PIC32MK GP Development Kit Product Change Notification

This document describes a required hardware change for the DM320106 – PIC32MK GP Development Kit (board revision # 04-10627_R2 only). The identified issues, as described below, will be implemented in future PCB revisions.

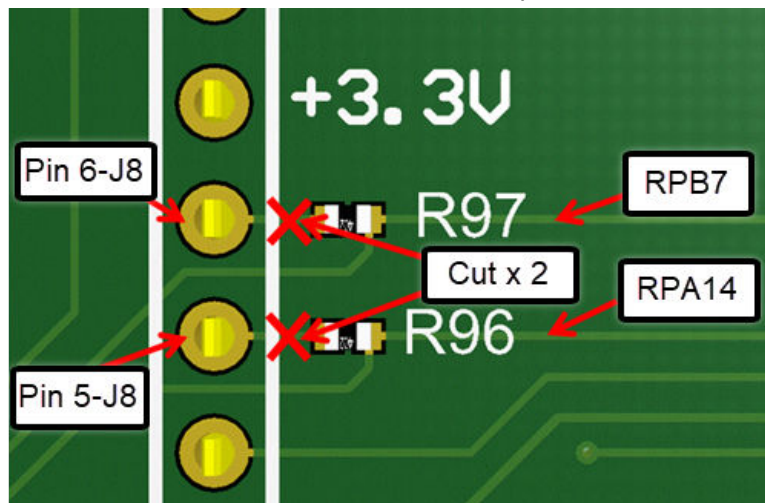
SPI2 Input (SDI2) and SPI2 Output (SDO2) connections to J8 mikroBUS™ header on the DM320106 – PIC32MK GP Development Kit (board revision # 04-10627_R2) are erroneously flipped.

Description of Hardware Change:

- RPA14/SDI2 must be connected to J8 – Pin 5 (MISO) through R96
- RPB7/SDO2 must be connected to J8 – Pin 6 (MOSI) through R97

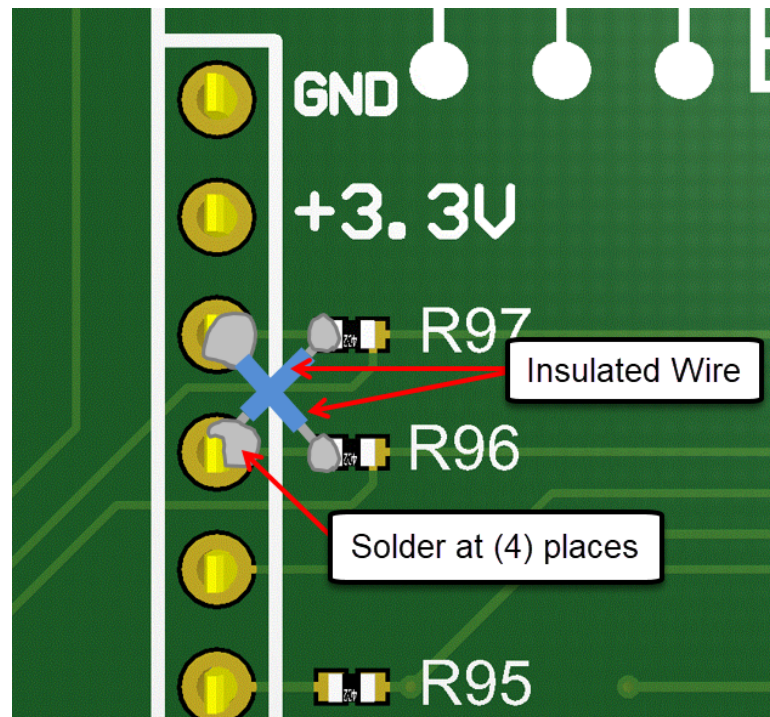
1. Scrape off the green mask, and then cut the trace at the two places, as shown in the figure below.

2. The following connections must be made by soldering the jumper wires, as shown in the following figure:
- R96 to Pin 6 – J8
 - R97 to Pin 5 – J8
